# Melbourne Planning Scheme Amendment C258

## 138-140 Stanley Street, West Melbourne

<b>Delegate Report</b>	DM#11693071
<b>Planner</b>	Rachel Grounds
<b>Contact</b>	Jane Birmingham
<b>Date of application:</b>	23 March 2018
<b>Date of report:</b>	19 June 2018

**Figure 3: Heritage Mapping**

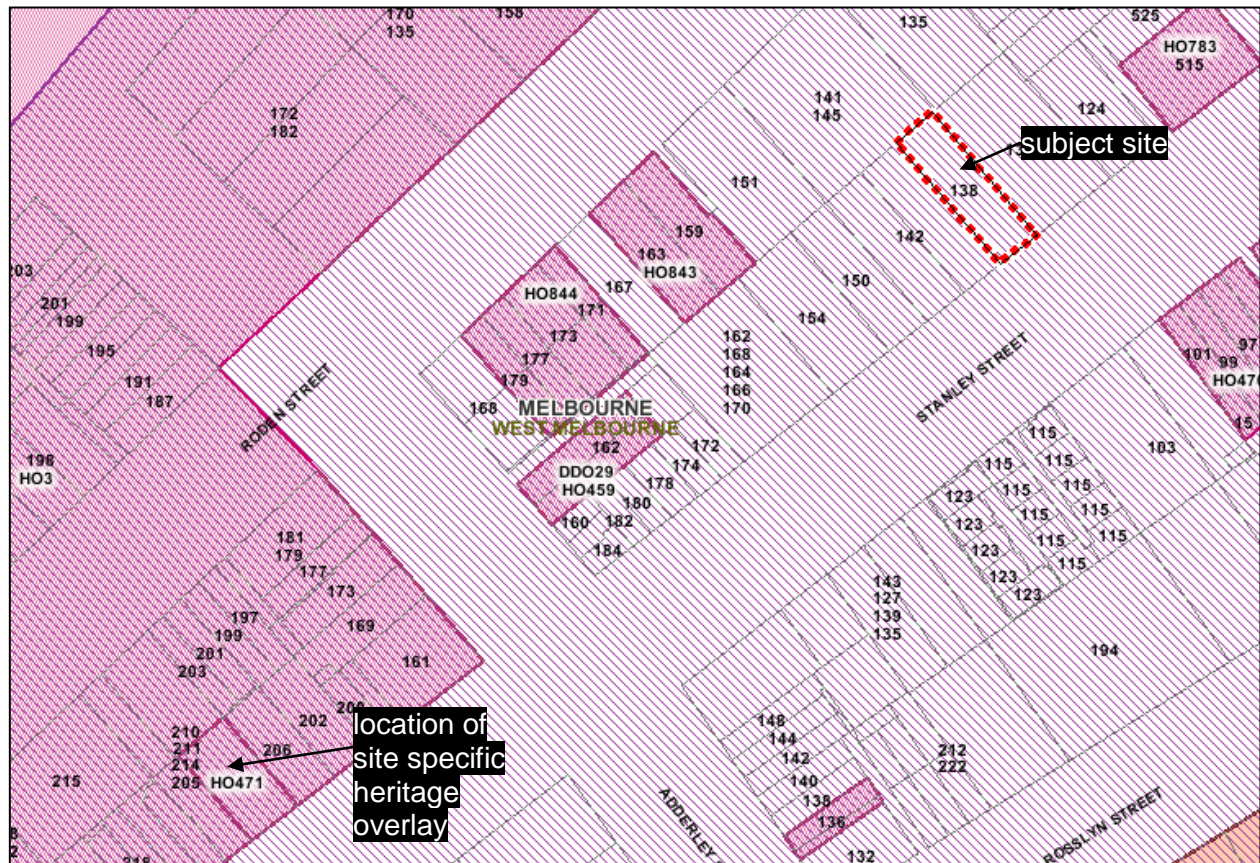
The exhibited Heritage Overlay mapping under Amendment C258 does not propose to include this property in the Heritage Overlay.

The subject site is therefore neither currently protected by a Heritage Overlay, nor proposed to be protected by a new Heritage Overlay under any exhibited Heritage Overlay map forming part of a Planning Scheme.

As such, and despite the unfortunate circumstances, the planning permit application can only be assessed against the planning controls affecting a given property at the time of the decision.

**Figure 5: Side and Rear Setbacks (non-compliance highlighted)**

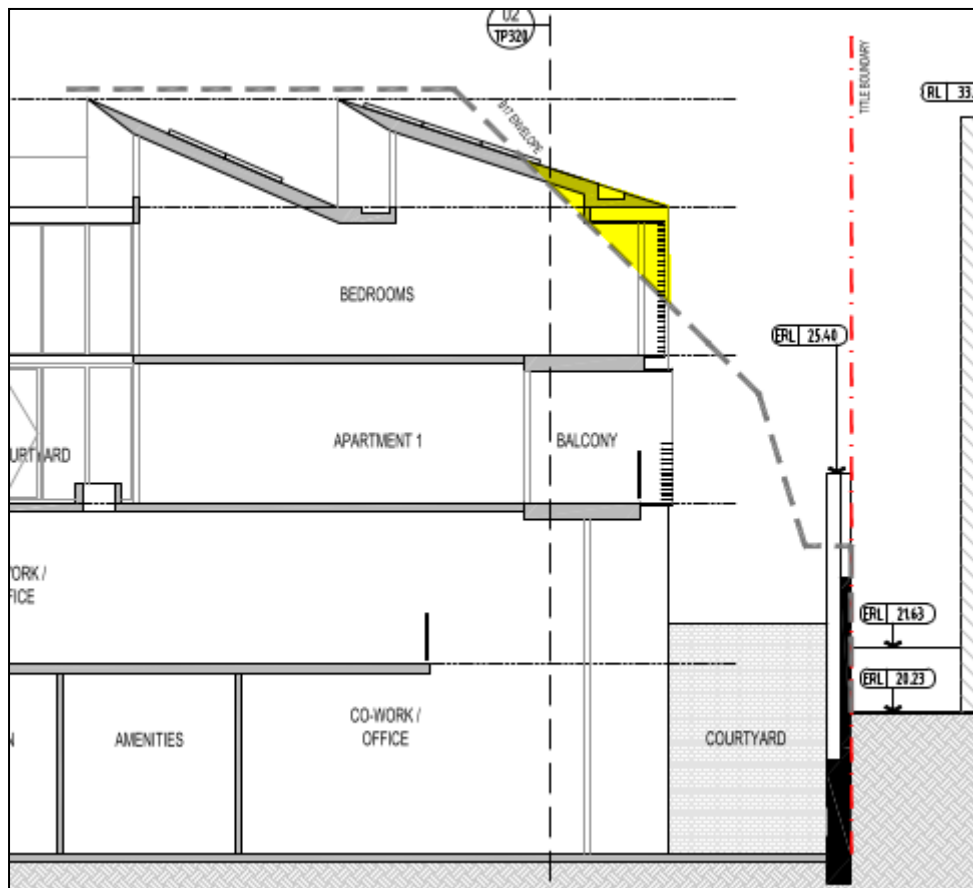
It is noted that the above table measures the wall height from the natural ground level (measured from the front of the site). As shown in Figure 5, the courtyard sits a considerable distance below the ground level of the neighbouring property to the rear. The applicants have provided a setback diagram measured from the ground level of the neighbouring site which demonstrates the minimal non-compliance with

the standard. It is considered that this variation to the standard is acceptable and will not result in any unreasonable detriment to the neighbouring property.

In addition, it is considered that the design response appropriately limits the presentation of the bulk of the built form through the placement of the balconies and the horizontal façade treatment.

**Figure 8: Overlooking potential between Apartments**

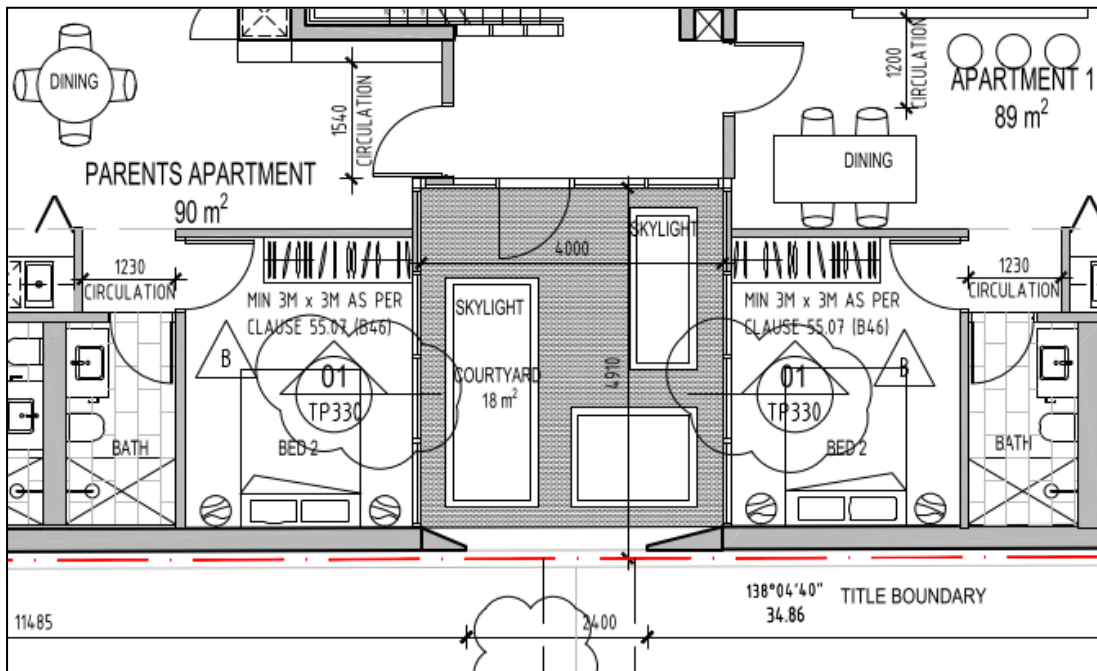
The application proposes to install 'horizontal line decals to achieve maximum 25% transparency up to 1.7m' in accordance with the requirements of Clause 55.04-7. The abovementioned conditional requirement will also require further detail for this screening device.
